Product Change Notification / LIAL-02XWMF227

CCB 5129 Final Notice: Qualification of G700 as a new molding compound material and NiPdAuAg with roughened as a new lead frame DAP surface prep for selected MIC7300, MIC2778, MIC833, and MIC2779 device families available in 5L SOT23 package assembled at STAR assembly site.

PCN #: LIAL-02XWMF227

Lead Frame Comparison

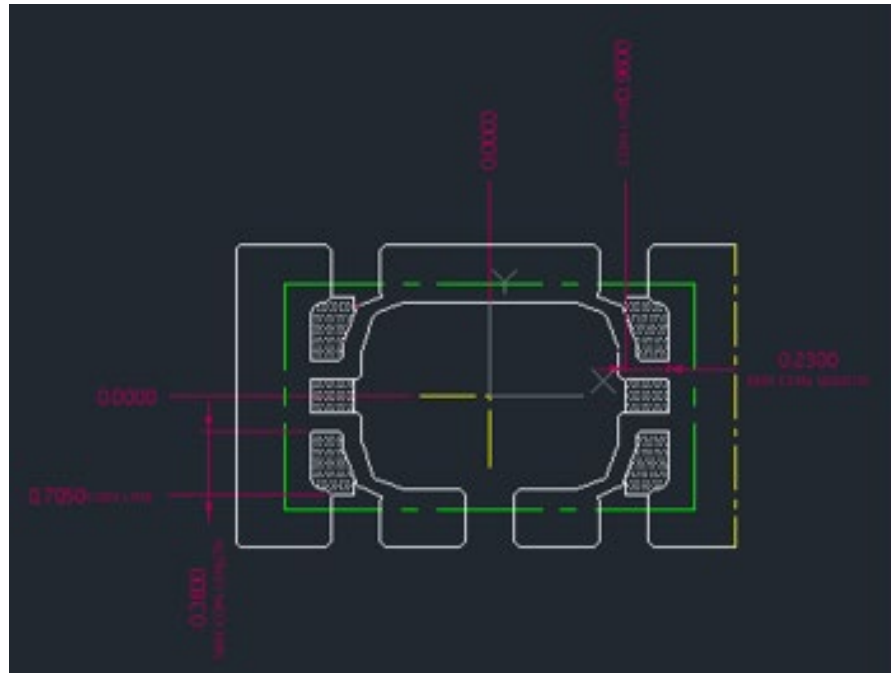
Description of Change:Qualification of G700 as a new molding compound material and NiPdAuAg with roughened as a new lead frame DAP surface prep for selected MIC7300, MIC2778, MIC833, and MIC2779 device families available in 5L SOT23 package assembled at STAR assembly site.
